State of Nevada Comments on NRC's Draft 2015 Yucca Mountain EIS Supplement

RE: Comments Regarding Supplement to the U.S. Department of Energy's Environmental Impact Statement for a Geologic Repository for the Disposal of Spent Nuclear Fuel and High-Level Radioactive Waste at Yucca Mountain, Nye County, Nevada, Draft Report for Comment, NUREG-2184, Docket ID NRC-2015-0051

**STATE OF NEVADA COMMENTS
ON THE
U.S. NUCLEAR REGULATORY COMMISSION
2015 DRAFT SUPPLEMENT TO THE U.S. DEPARTMENT
OF ENERGY'S ENVIRONMENTAL IMPACT
STATEMENT FOR A GEOLOGIC REPOSITORY FOR
THE DISPOSAL OF SPENT NUCLEAR FUEL AND
HIGH-LEVEL RADIOACTIVE WASTE AT
YUCCA MOUNTAIN,
NYE COUNTY, NEVADA (NUREG-2184)**

Figure 7.12.1. Conceptual representation of the Conceptual Divide Theory (Farmer and others, 2003)

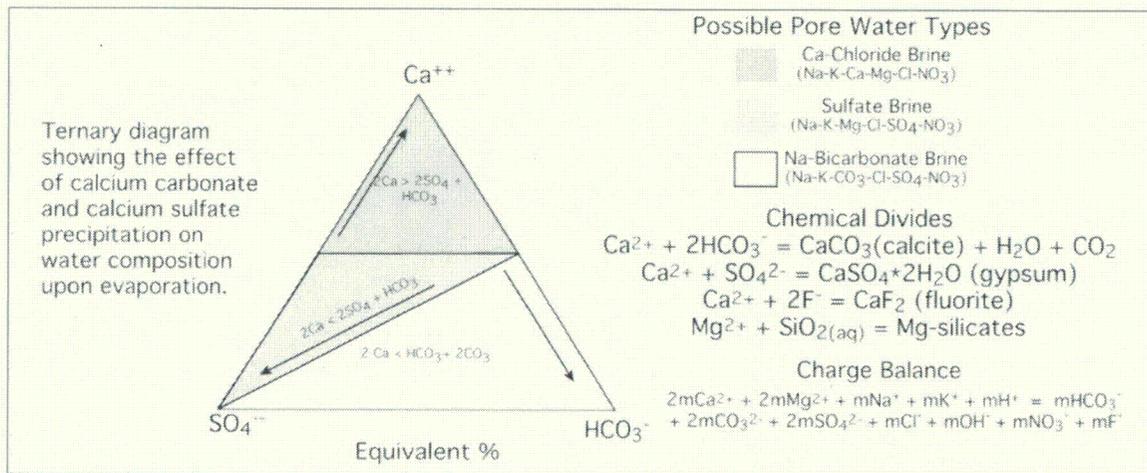
DOE, and the NRC Staff in the 2015 Draft Supplement, have not evaluated the importance of environmental vanadium in controlling dissolved uranium concentrations in groundwater. The vanadium-bearing uranium minerals carnotite and tyuyamunite are absent from the most recent

Project thermodynamic databases (Wolery and Sutton, 2011) and therefore suppressed by omission. Worldwide, high concentrations of vanadium are often found in groundwaters associated with basalt (Wright and Belitz, 2010; Terada and Naotatsu, 2011). It was not until Alloy-22 gained acceptance that vanadium was even considered as a potential contaminant, but never has it been comprehensively evaluated in terms of environmental sources in the Yucca Mountain region. Potential interactions with uranium when they co-exist in solution can include mineral precipitation. The aqueous geochemistry of vanadium is far more complex than the simple, sorption-dominated DOE/NRC treatment, whether on the process-model or abstracted levels of analysis (Wright and others, 2014).

Figure 8.1. Relation between weighted mean annual temperature, precipitation and runoff (modified after Mifflin and Wheat, 1979). Presented to NWTRB by M.D. Mifflin, April 21, 1993.

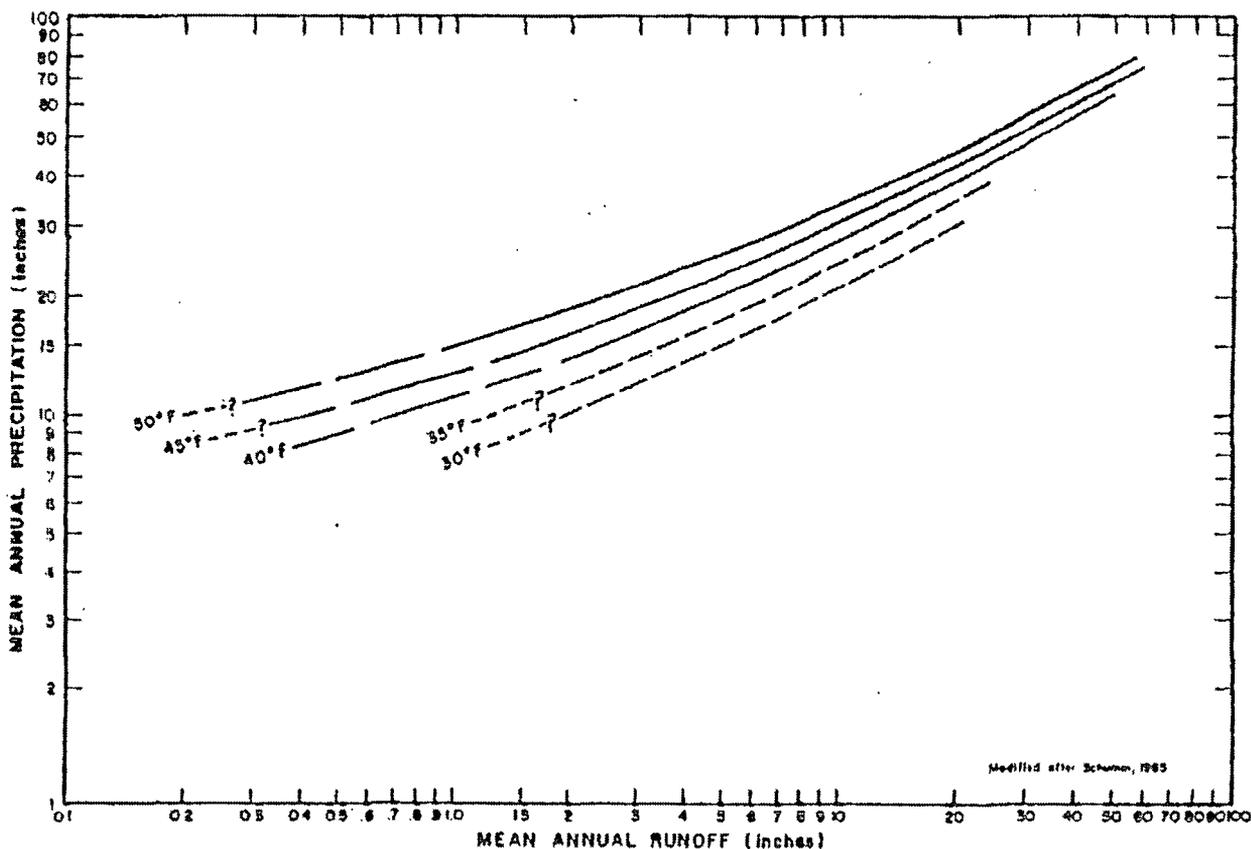
Perhaps NRC needs to better distinguish between the terms *infiltration* and *climate*, which have been conflated by rulemaking (10 CFR 63.342(c)(2), a circumstance that cannot lawfully support failure to analyze potentially significant impacts here. The prescribed distribution and average of infiltration rates may not be realistic, could be sustained by a range of temperature/precipitation combinations, and should be cross-checked with regional water balance for validation of the legislated infiltration rates which NRC itself prescribed. Performance assessments sample from a specified distribution of infiltration (percolation) values through the repository but it should be recognized that there is a spectrum of temperature/precipitation pairs (Figure 8.1) that could produce the assumed infiltration.

A distribution of possible runoff conditions (due to uncertain precipitation) should force consideration of several saturated-zone (SZ) flow fields, each corresponding to a precipitation rate applied to the net-infiltration model and therein transformed to infiltration and runoff and exported to the groundwater model as “river” losses. Some paths within the set of flow fields determined this way would be more consequential than others, and would not be known from

present conditions or scaled derivatives of present conditions as the Draft Supplement appears to have assumed. Climate is implicit in each realization of the TSPA chain of analyses. Beginning with the selection of a single value from a net-infiltration distribution, the DVRFS model should produce a unique groundwater flow field as water is allowed to recharge along Fortymile Wash. Mass balance in the DVRFS model must be consistent with and constrained by the size of any corresponding lake in Death Valley. The sedimentary record there and at Devils Hole provide tests of water balance and paleotemperature.

Figure 12.1

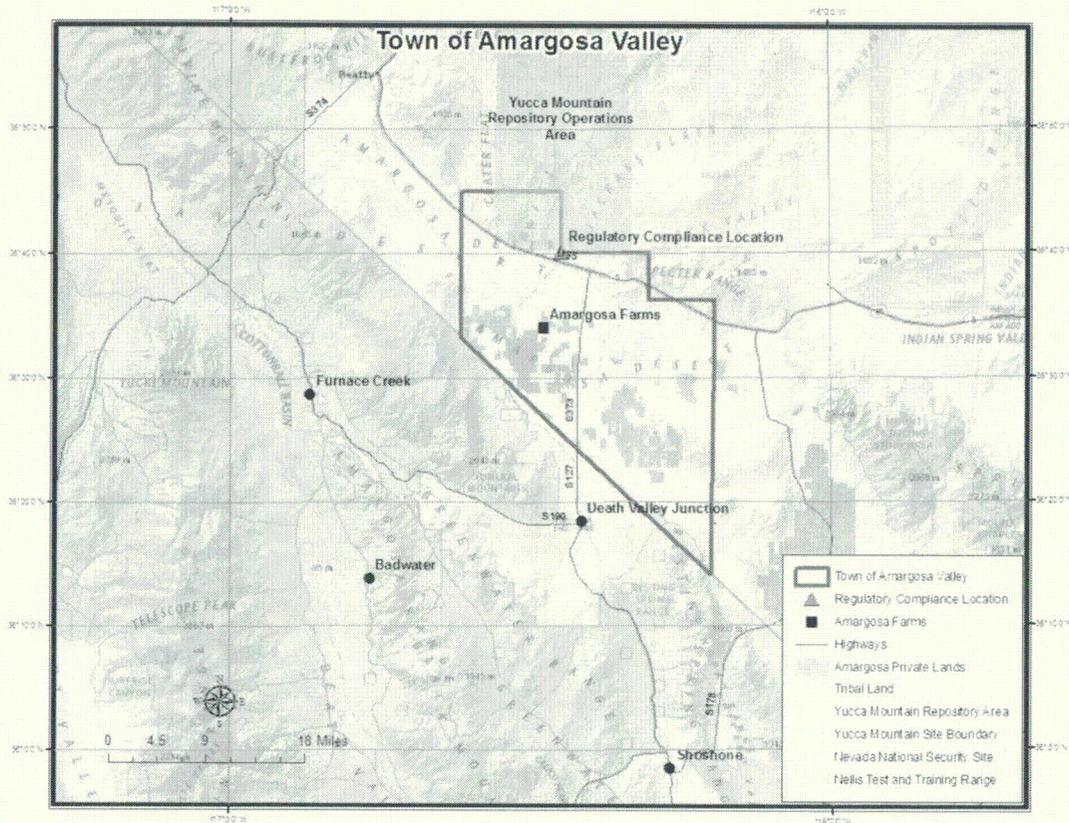
The 2015 Draft Supplement also fails to acknowledge the locally significant presence of privately owned lands in the vicinity of the Amargosa Farms pumping location used for analyzing groundwater impacts. The Draft Supplement fails to identify the potentially affected privately owned properties, and the associated water wells, by owner. Likewise, the Draft Supplement fails to evaluate the potential direct and indirect social and economic impacts of Yucca Mountain groundwater discharges on privately owned land and water resources in the Town of Amargosa Valley. Any final EIS Supplement must be revised to provide a sufficient description of privately owned lands that would be part of the affected environment.

Figures 12.1 and 12.2, prepared by the State of Nevada, show the location of privately-owned lands and privately owned water wells relative to the regulatory compliance location and the Amargosa Farms pumping location. The final EIS Supplement must be revised to provide a sufficient description of the co-location of privately owned water wells and privately owned lands that would be part of the affected environment.

Figure 19.1

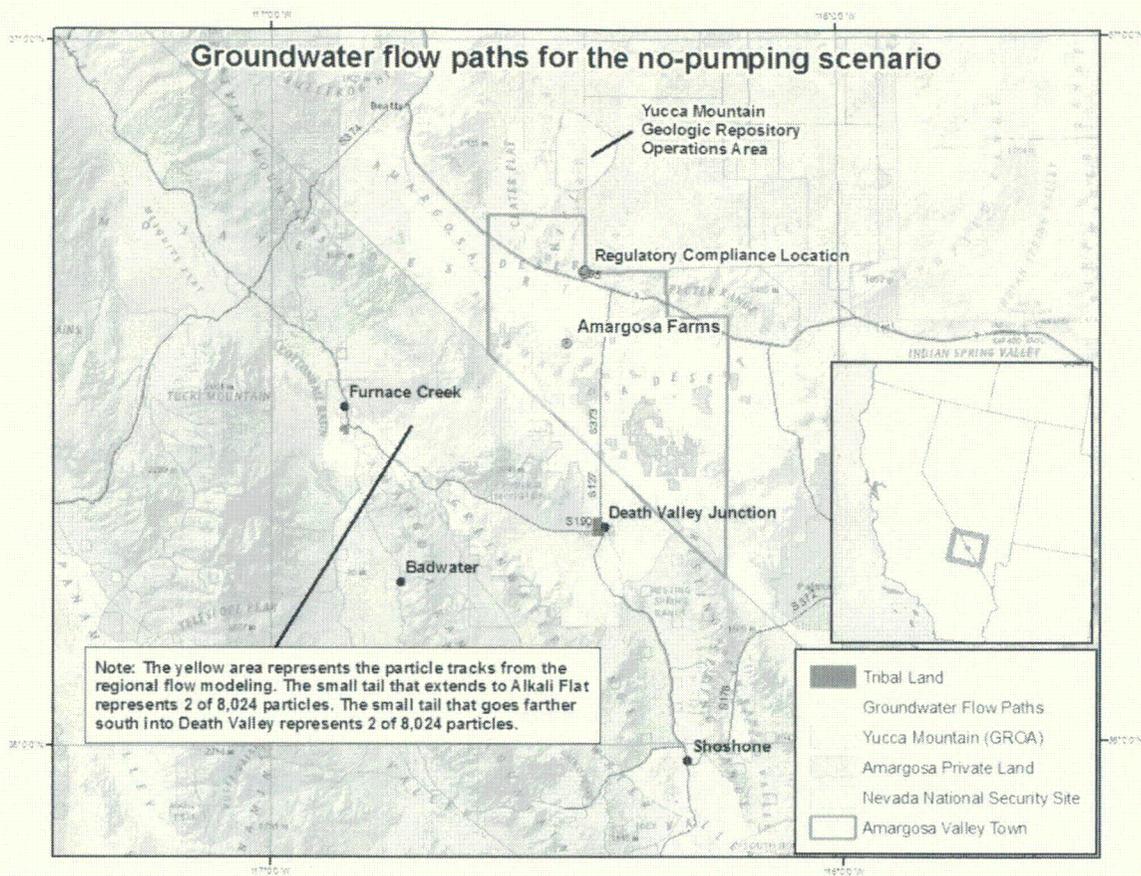
The 2015 Draft Supplement's failure to address these Native American concerns is further compounded by failure to include detailed maps showing the likely groundwater impacts of the no-pumping scenario, documented in a previous report by Sandia National Laboratories for DOE, on Native American cultural and spiritual resources in the affected area. The Draft Supplement should have specifically included a graphic depiction of potential impacts on the springs in the Furnace Creek area, as shown in Figure S-4, Groundwater Flow Paths for the No-Pumping Scenario, found on page S-12, U.S. DOE, Analysis of Postclosure Groundwater Impacts for a Geologic Repository for the Disposal of Spent Nuclear Fuel and High-Level Radioactive Waste at Yucca Mountain, Nye County, Nevada: Summary, RWEV-REP-0001-Update, October 2014.

The State of Nevada has prepared the following map (Figure 19.1) based on the information provided to NRC by DOE in the above referenced document. Nevada's map shows that groundwater discharges under the no-pumping scenario would be expected to impact both tribal lands and springs located on non-tribal lands in the Furnace Creek area.
